Relocation of SR 113 From CR 31 To Richland  
Creek @ Old Alabama Road Relocation – Phase II  
P.I. Nos. 621440 and 621445  
STP00-0179-01(010) and BHF00-0179-01(011)

Value Engineering Study Report

July 2010

AMERICAN ENGINEERS, INC.

ALT. NO.  
R-10/R-11  
SM. 7 of 14

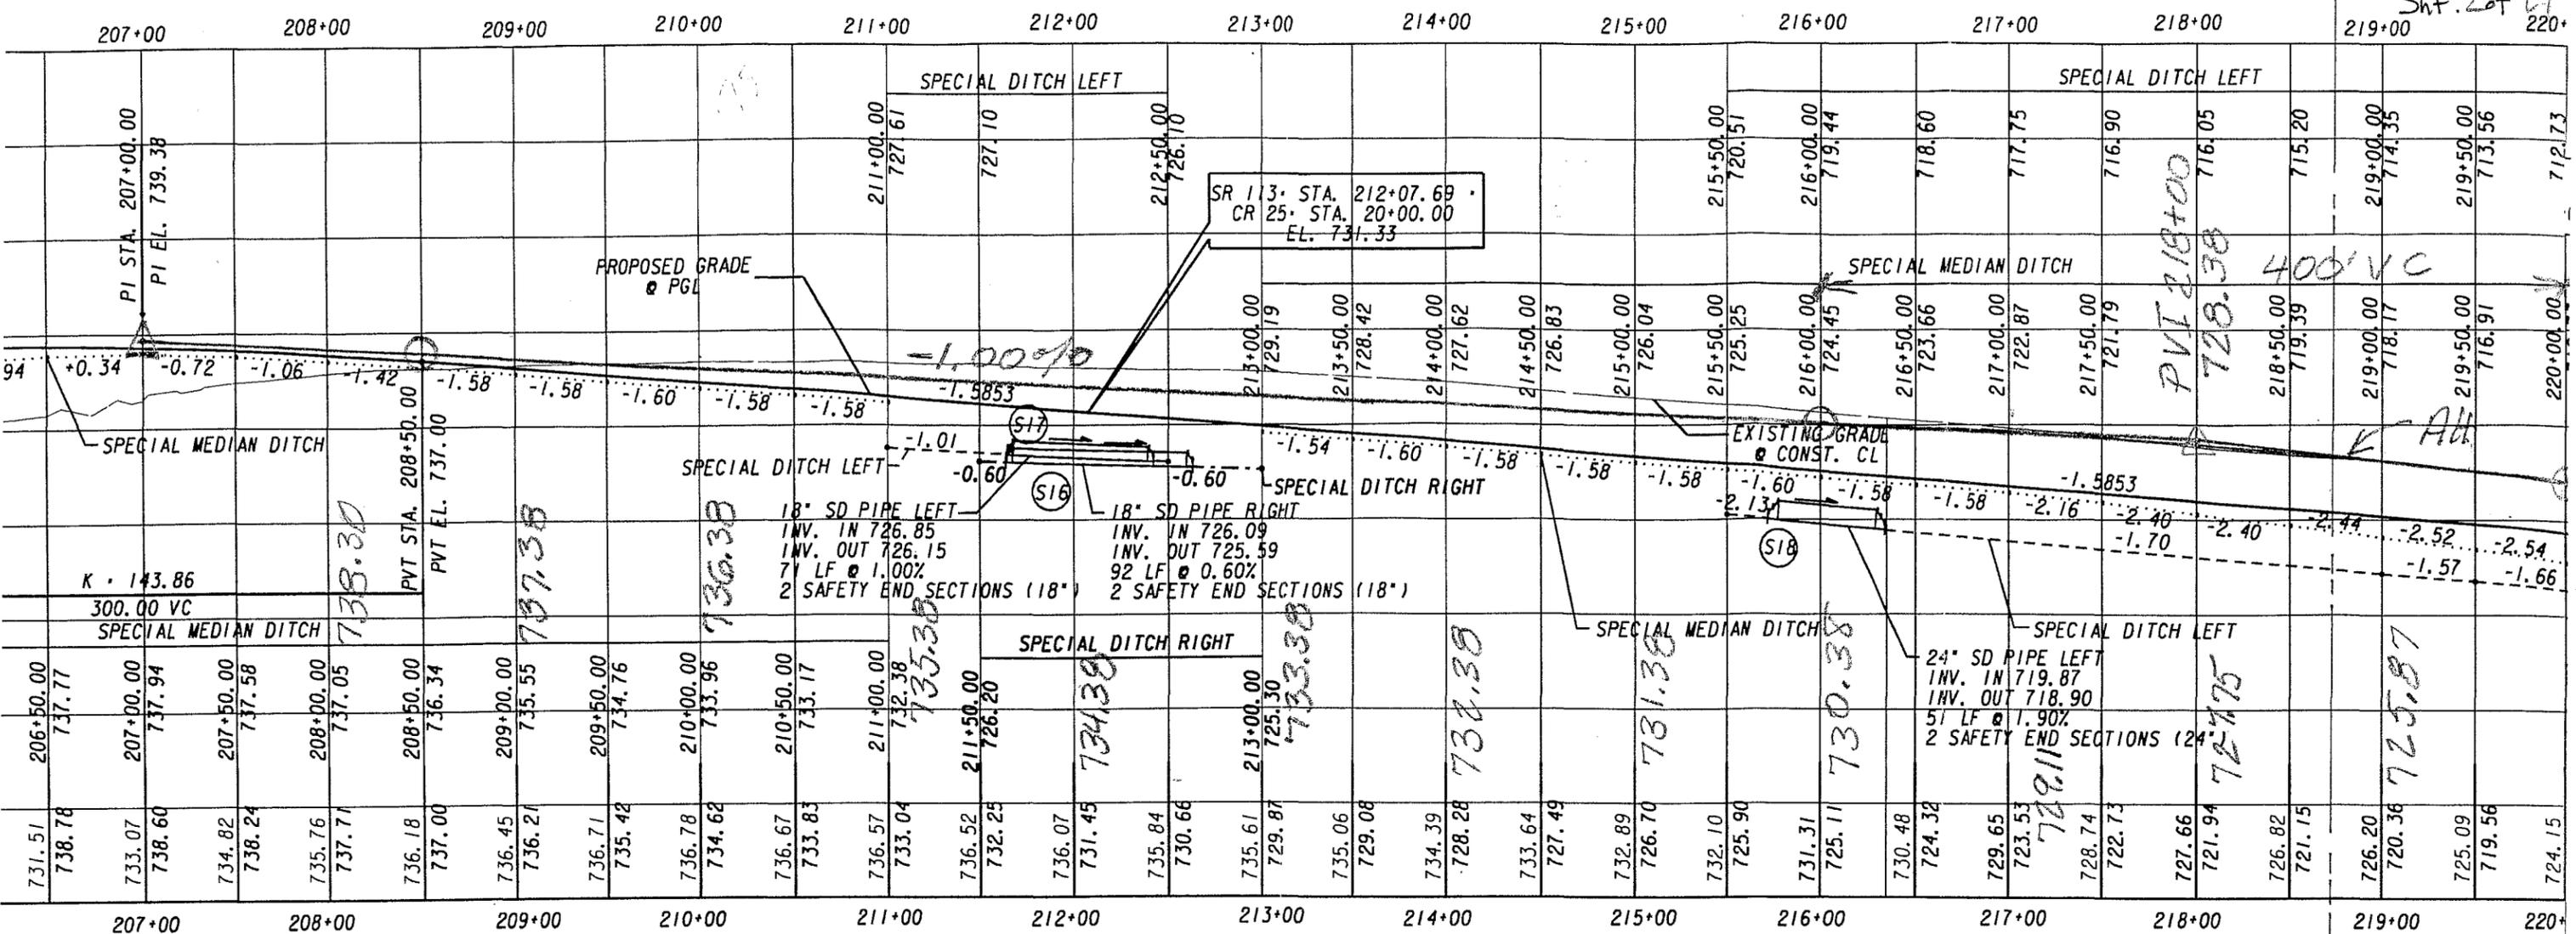
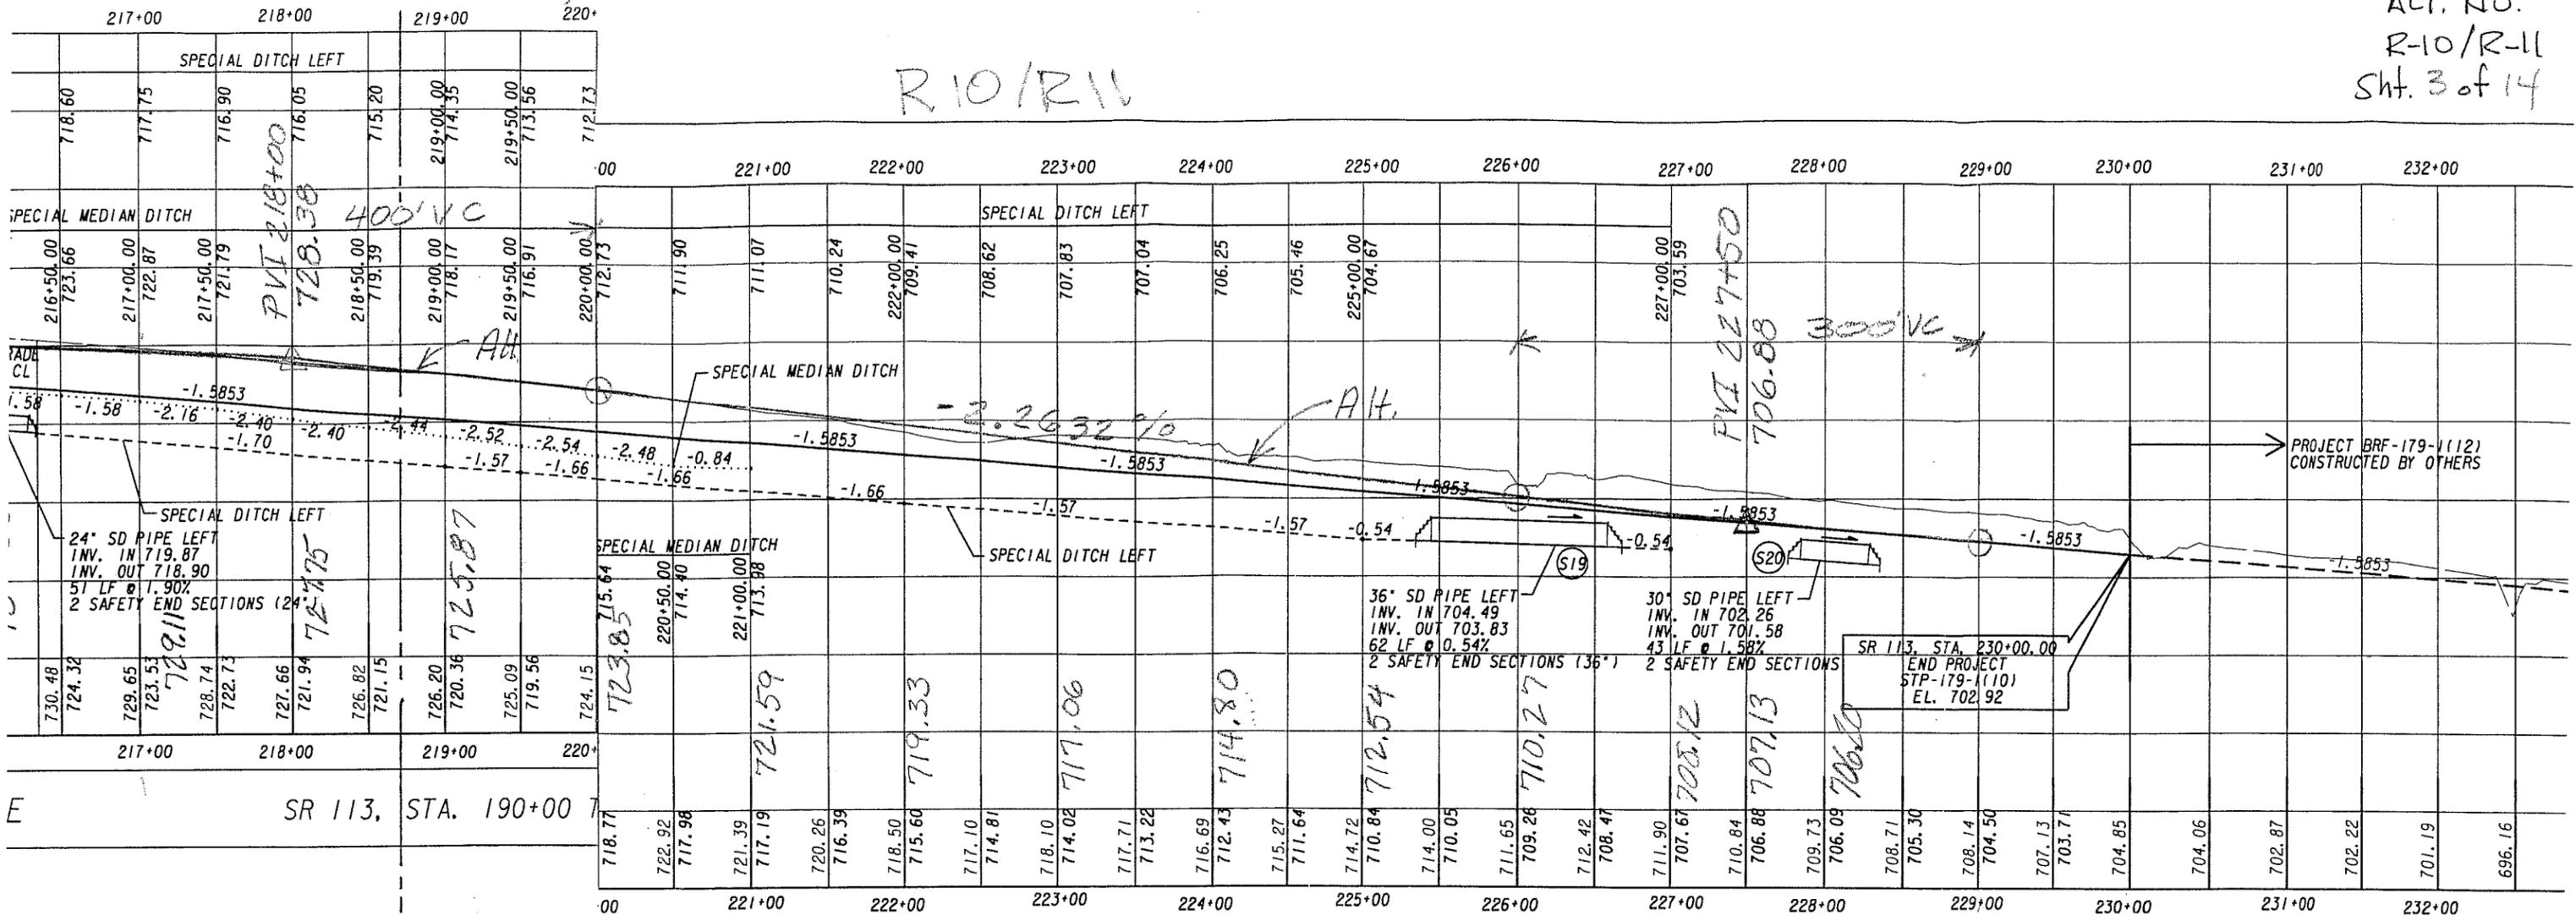
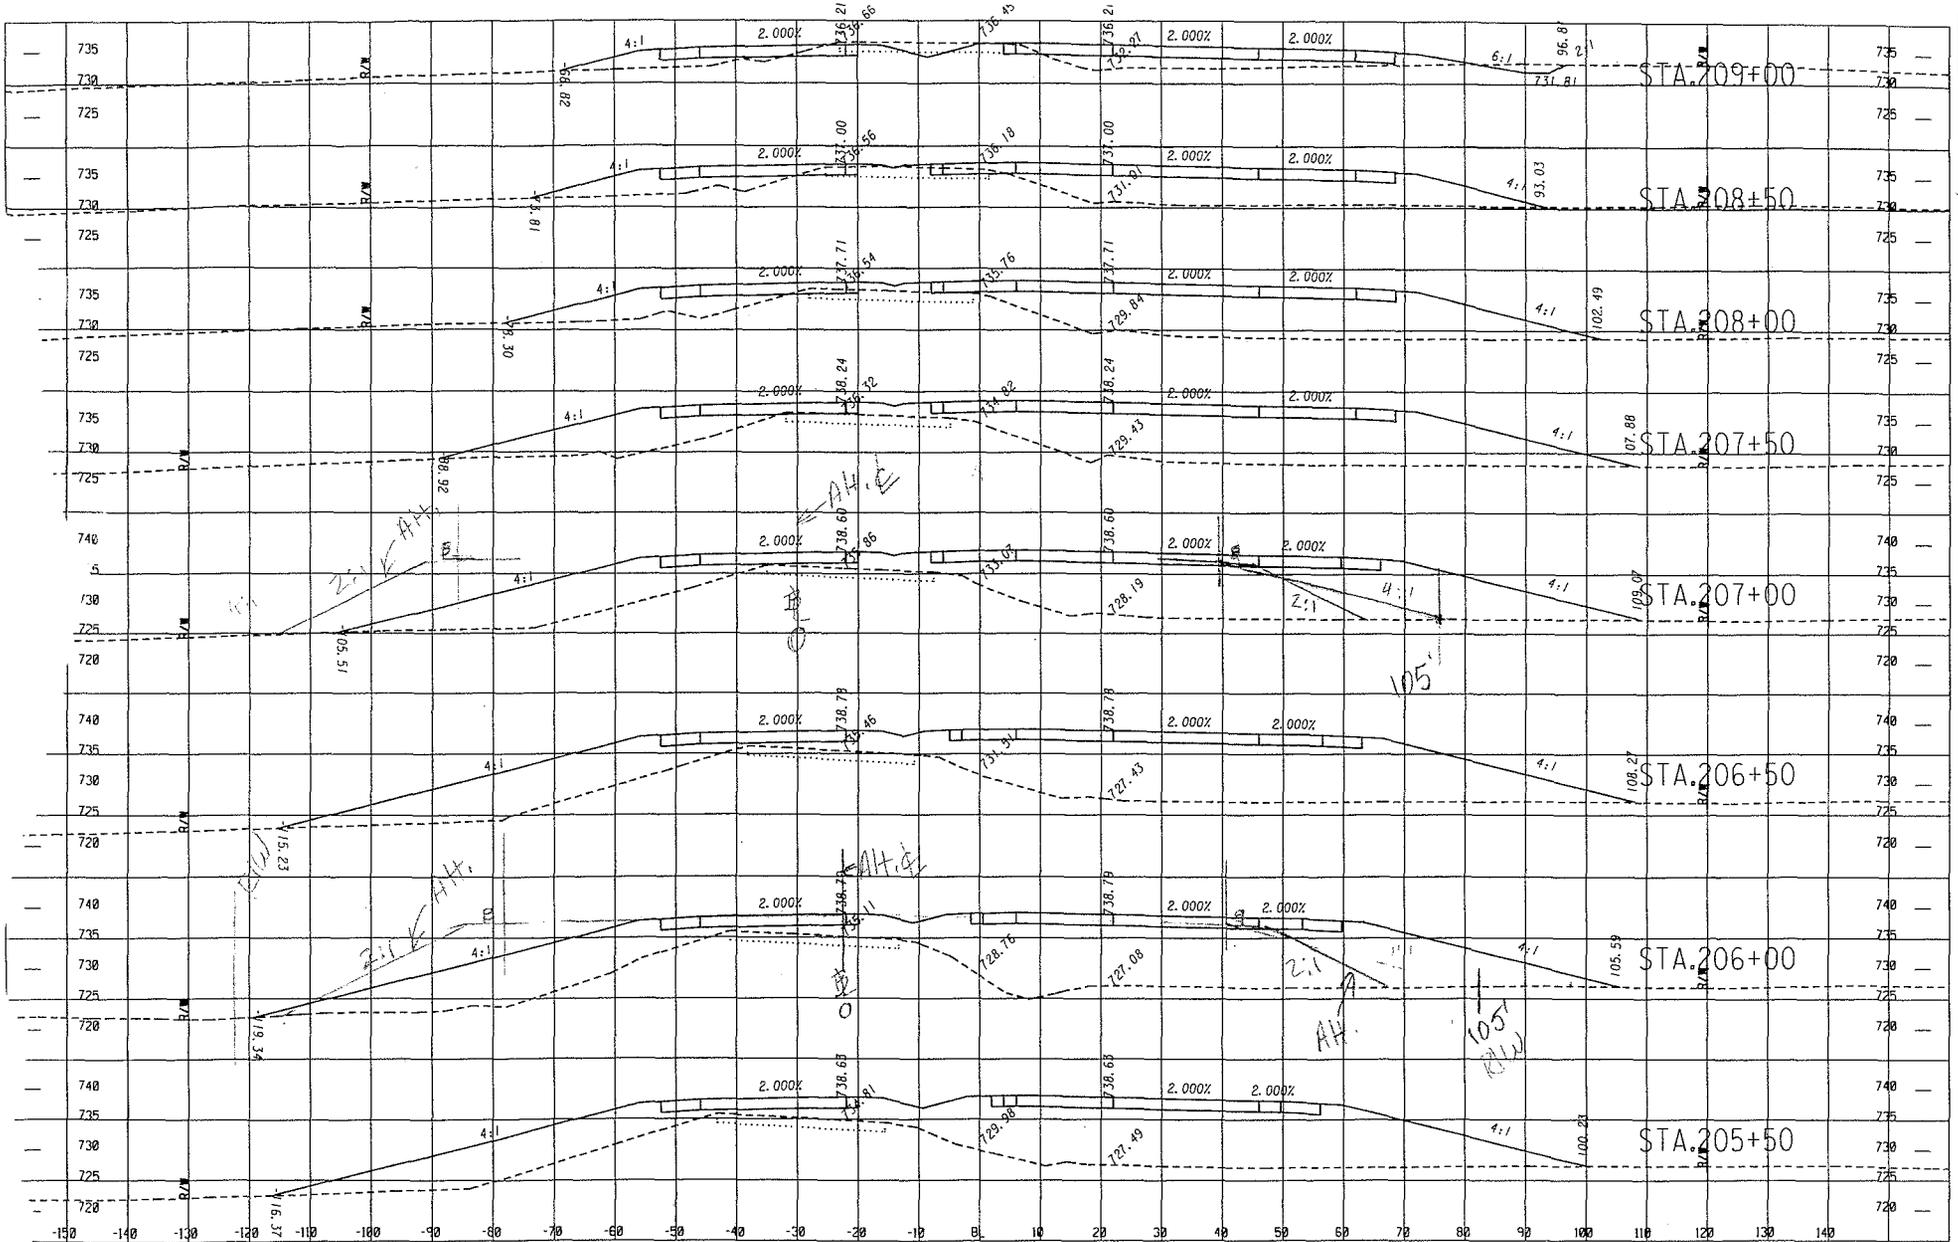
- Reduces right of way impacts
- Reduces right of way requirements
- Reduces unclassified excavation requirements

- Increases retaining wall, guardrail, and drainage construction requirements
